# Product Change Notification

## 108396 - 00

**Change Notification #:** 108396 - 00  
**Change Title:** SC5400 Server Chassis, PCN 108396-00,  
Product Design, Addition of mounting holes  
to support future generation server boards  
**Date of Publication:** April 15, 2008

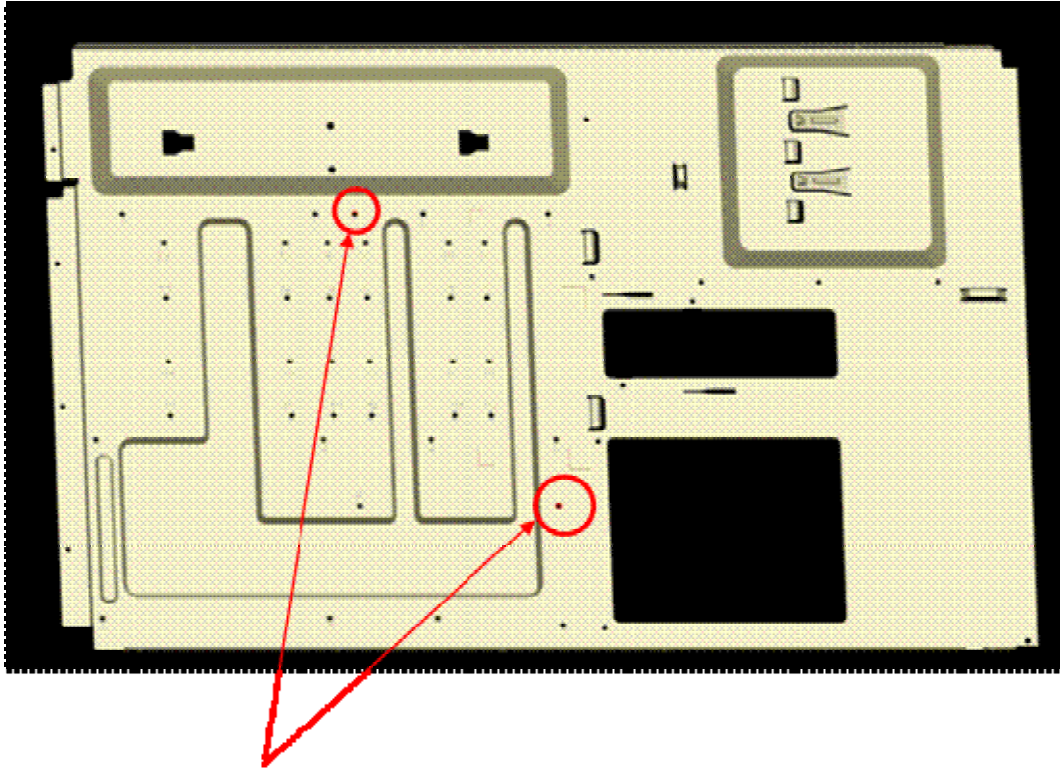
Addition of 2 6-32 tapped extrude holes for motherboard mounting.

**Add 2 6-32 tapped extrude holes for motherboard mounting.**

This change will have no impact to the current generation of motherboards being mounted in the SC5400 chassis. This will be a visual impact only and therefore Intel recommends that no further validation is necessary.
